RESPONSE TO COUNTY DEFINCIENCY NOTICE:

REVISED SITE PLAN
DRAFIED FO

LIDVING WORKSHOP 5070 Weatherford Rd Flagstaff, AZ 86001

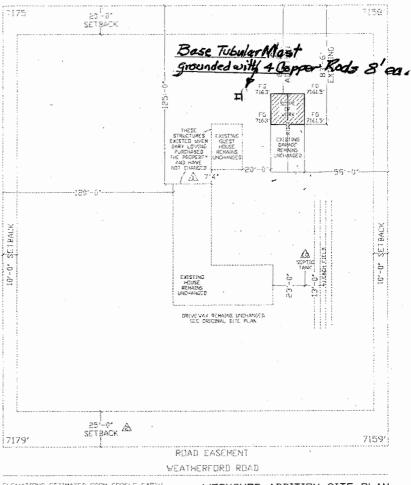
EQ LOCATION OF SEPTIC TANK AND LEACH FIELD.

- 1. GUEST HOUSE CORNER IS 7'4" FROM EXISTING ATTACHED GARAGE CORNER, THESE STRUCTURES EXISTED WHEN GARY LOVING PURCHASED THE PROPERTY, THE STRUCTURES AND LOCATION HAVE NOT CHANGED IN THAT TIME.
- 2, 25' SETBACK NOTATION HAS BEEN MOVED TO BACK OF WEATHERFORD RD. RIGHT OF WAY.

THE DRIGINAL SITE PLAN HAS NOT CHANGED WITH REVISION FOR REDLINES.
